**STATE OF CALIFORNIA  
DEPARTMENT OF WATER RESOURCES**

**STATEMENT OF FINDINGS REGARDING THE  
DISAPPROVAL OF  
THE SOUTH AMERICAN SUBBASIN ALTERNATIVE**

State of California  
Department of Water Resources  
Sustainable Groundwater Management Program  
Alternative Assessment Staff Report

Groundwater Basin Name: Sacramento Valley - South American (5-021.65)  
Submitting Agency: Sacramento Central Groundwater Authority  
Recommendation: Do Not Approve  
Date Issued: July 17, 2019

*Figure 1 – Sacramento County Groundwater Basins – Central Basin Boundary Compared with South American Subbasin Boundary*

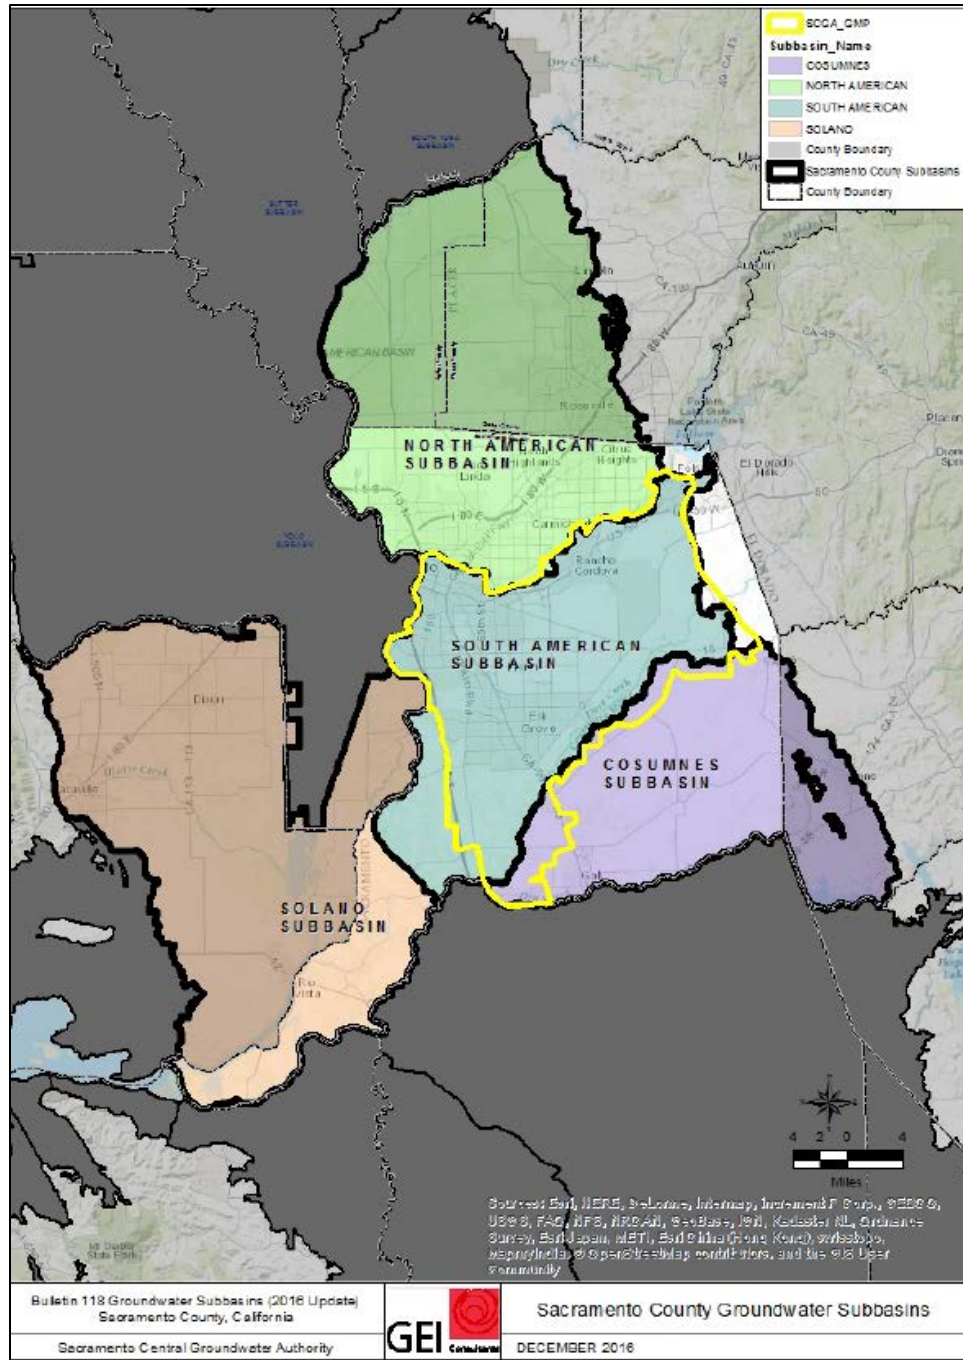
documents as the Central Basin (outlined in yellow on Figure 1).<sup>32</sup> The boundaries of the Central Basin overlap, but do not entirely cover the South American Subbasin (shown in teal on Figure 1) as defined in Bulletin 118. The Central Basin does not include the southwestern corner of the South American Subbasin, which lies in the Sacramento-San Joaquin Delta,<sup>33</sup> and extends south into the adjacent Cosumnes Subbasin (shown in lavender on Figure 1), as well as exhibiting other minor boundary deviations. To demonstrate that the SCGA groundwater management effectively covers the entire basin, SCGA presents an analysis to relate the sustainable yield defined for the Central Basin to the South American Subbasin.<sup>34</sup>

To determine whether the Alternative effectively covers the entire Subbasin, Department staff are required to determine whether groundwater management pursuant to the Alternative has avoided undesirable results in the entire Subbasin for at least 10 years. Because Department staff have determined that the Analysis of Basin Conditions does not demonstrate that undesirable results have been absent for at least 10 years, even

within the locally-defined Central Basin, the Department staff are unable to determine the South American Subbasin has been managed sustainably. As a result, Department staff cannot conclude that the Alternative effectively covers the entire Subbasin. Although the failure to cover the entire Subbasin precludes the Alternative from approval, Department staff note that the failure to effectively cover the entire Subbasin is a consequence of the Alternative not demonstrating sustainability in the area within SCGA's jurisdiction. Department staff do not express an opinion as to whether the area managed by SCGA would be sufficient to effectively manage the entire South American Subbasin if sustainable groundwater management had been sufficiently demonstrated.
